Project No. 116-07-2014

Rebuttal Report on Expert Witness Reports Submitted by Hydro Logic Inc (Ed Squires), and Bill Bonnicksen, and DuWayne Kimball relative to Water Right Transfers 79357, 79380, 79384, and 79466

Cedar Ridge Dairy
Filer, Idaho

March 6, 2015

Figure 1: Map Identifying Previous Approved Transfer Locations and Currently Proposed Transfer Locations.

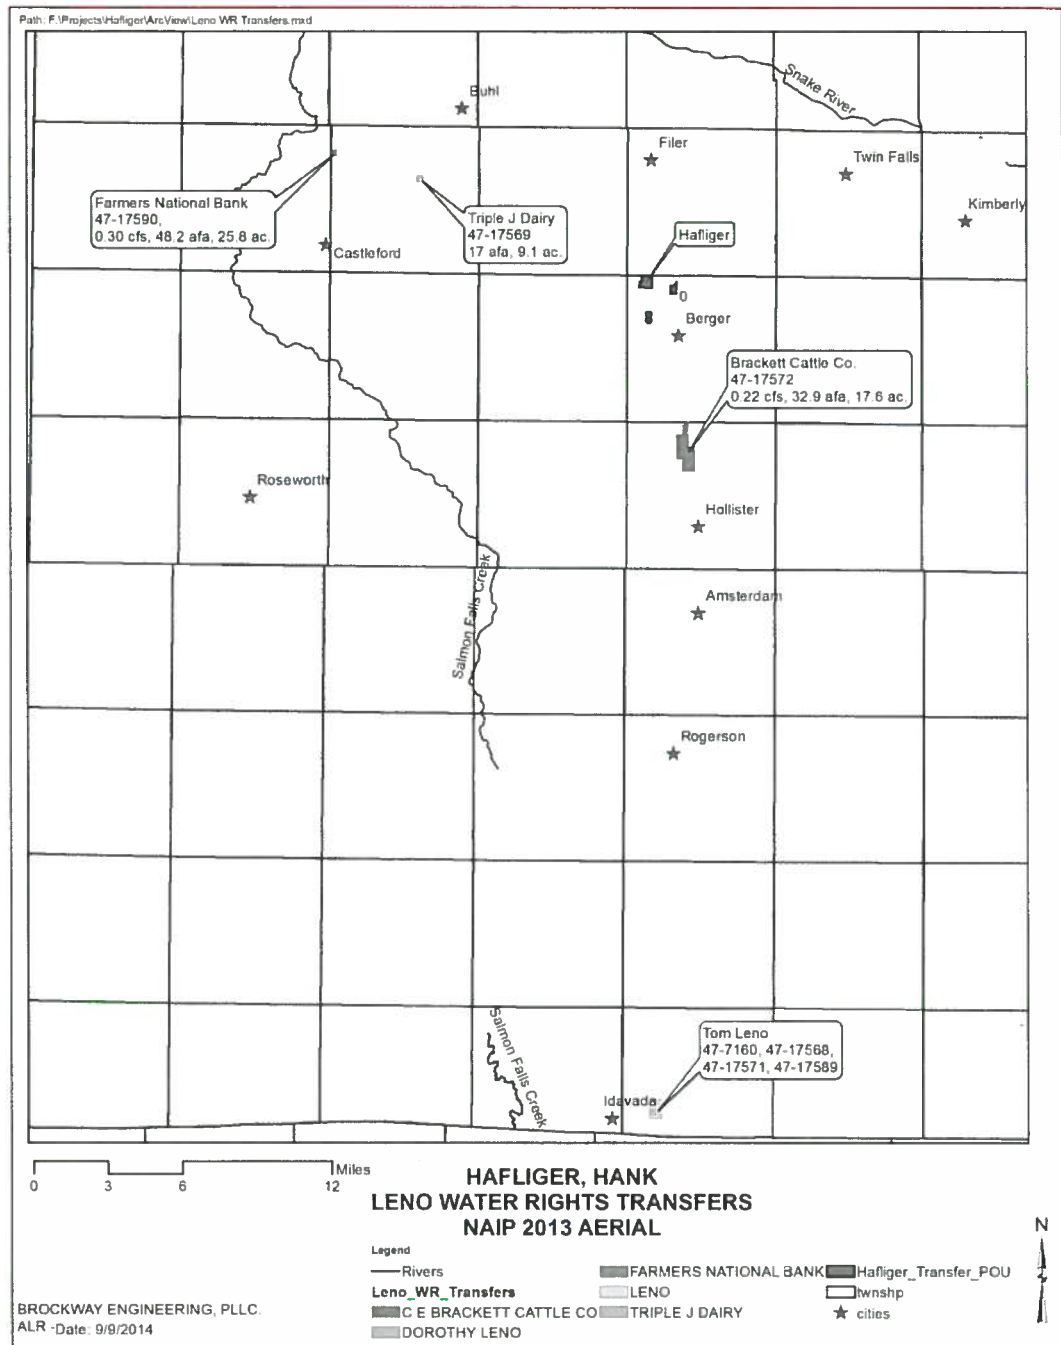
It is inferred by Mr. Squires that the priority of the water right proposed for transfer, 47-17589 would likely need to be changed in some way to mitigate for impacts to existing wells at the new location (Paragraph 3, ii, page 6, Hydro Logic). Our experience is contrary to this assertion. In fact, the three water right transfers from this same water right approved by IDWR to be moved to areas in the same general vicinity have not resulted in any required changes in priority

(Figure 1). There is no reason to assume that approval of Transfer 79384 will require a change in water right priority.

Figure 2: Well Locations on the Leno Ranch

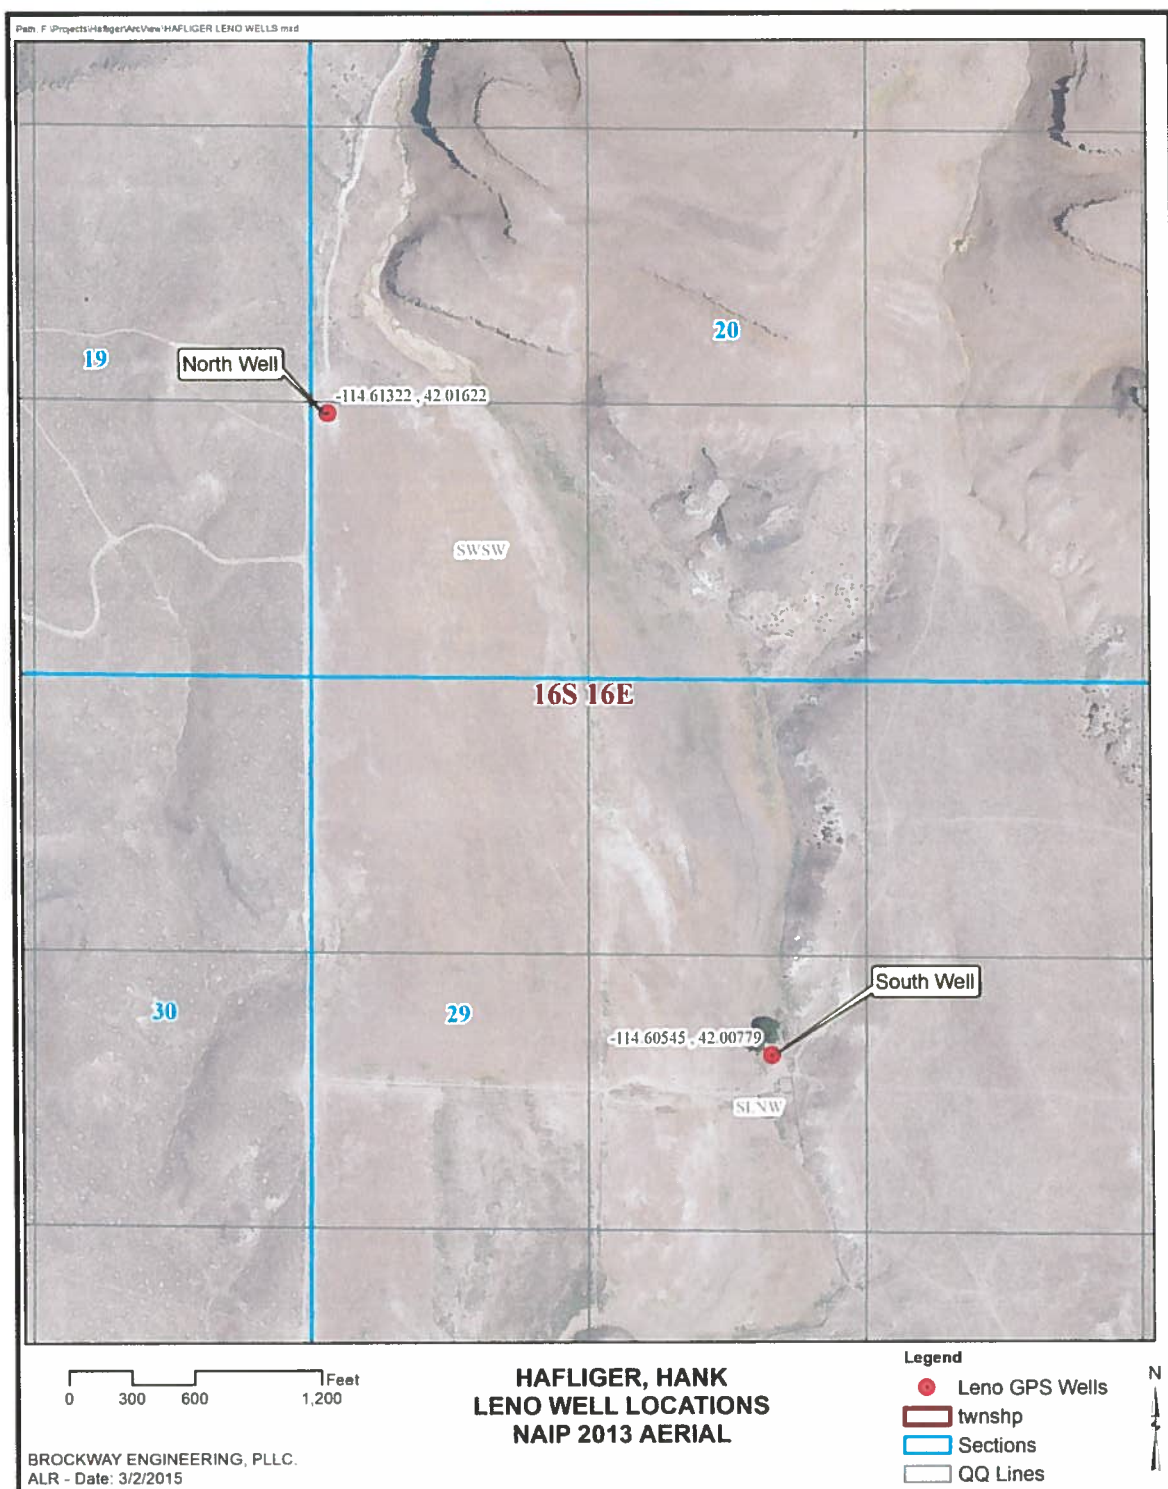
The two wells in the Mule Creek drainage identified by Kimball are located on property previously owned by the Applicant Thomas Leno (Figure 2). The south well identified by Kimball is actually located approximately one mile north of the location identified in Kimball's report. This well is the irrigation well utilized for irrigation from parent water right 47-7106. The north well identified by Kimball is actually a domestic well for a house located on the Leno property. The house is currently abandoned. Well logs for the two wells is provided in Appendix A.

The irrigation well is located approximately $\frac{3}{4}$ of a mile north west of the domestic well. The GPS elevations and coordinates for the irrigation and the domestic well

have been obtained. The ground surface elevation at the irrigation well is 5,701 feet and the ground surface elevation for the domestic well is 5,583 feet. The static water level in the irrigation well is 77 feet below the ground surface based on the well drillers log. The static water level in the domestic well is 18 feet below the ground surface based on the well driller's log. A diagram of the relationship of the ground surface elevation and the static water level in each well (based on the well drillers reports) is provided in Appendix A. Photographs of the irrigation well and domestic well are included in Appendix A.
